**STAFF REPORT
(One-Step Final Plat)**

CASE NUMBER: SUB 2003-54 -- LILLIE ADDITION

RE: Lillie Addition Drainage

SUBJECT: Drainage Plan
Lillie Addition
Wichita, Kansas

VICINITY MAP

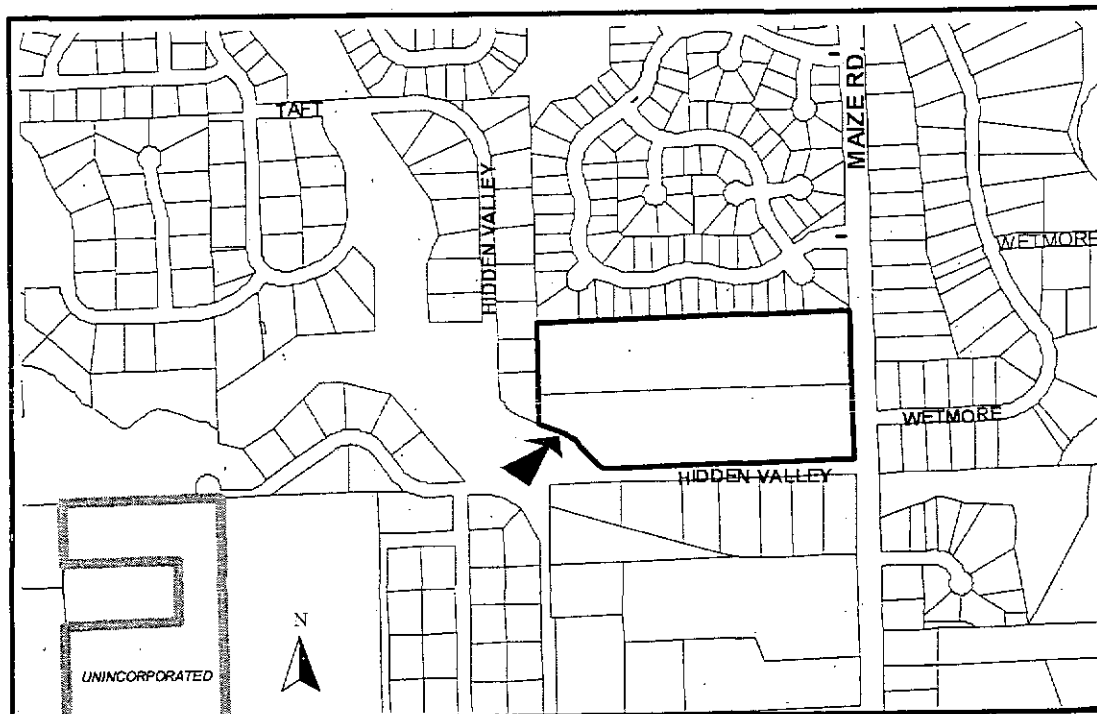
- G. Traffic Engineering has requested a petition for contingent turn lanes.
- H. The location of the plat needs to be revised on the vicinity map.
- I. The range "1E" needs to be revised to "1W" as shown on the vicinity map.
